**Register Reference:** SD22B/0372 **Date:** 15-Sep-2022  
**Development:** The proposed development will consist of:  
**(1) Conversion of existing garage to living space. (2) A first floor side extension above the existing structure. (3) A redesigned porch/entrance. (4) A ground floor extension to the rear. (5) A redesigned front boundary wall and all associated site works.**  
**Location:** 22, Old Bawn Park, Dublin 24. D24 VH9D.  
**Applicant:** Emlyn Brennan & Anita Berney  
**App. Type:** Permission  
**Planning Officer:** CIARAN STANLEY  
**Date Recd:** 19-Aug-2022  
**Decision Due Date:** 13-Oct-2022

**Description:**

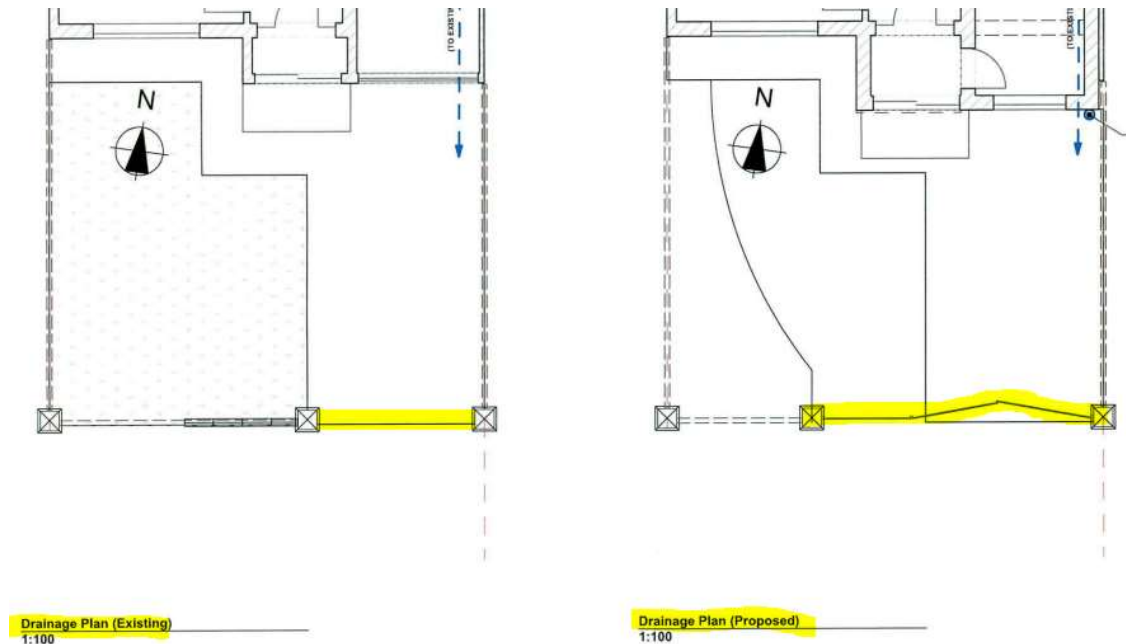
The applicant has provided little detail re proposed amendments to the front boundary wall. An excerpt from the submitted drainage drawing is shown above. SDCC Roads Department standard condition states that a vehicular access point shall not exceed a width of 3.5 meters. Applicant to submit a revised drawing which complies with this condition.

1. Applicant to submit revised and clearly dimensioned plan/elevation drawings that show a vehicular access point which does not exceed 3.5m in width.  
Reason: In the interest of pedestrian safety.
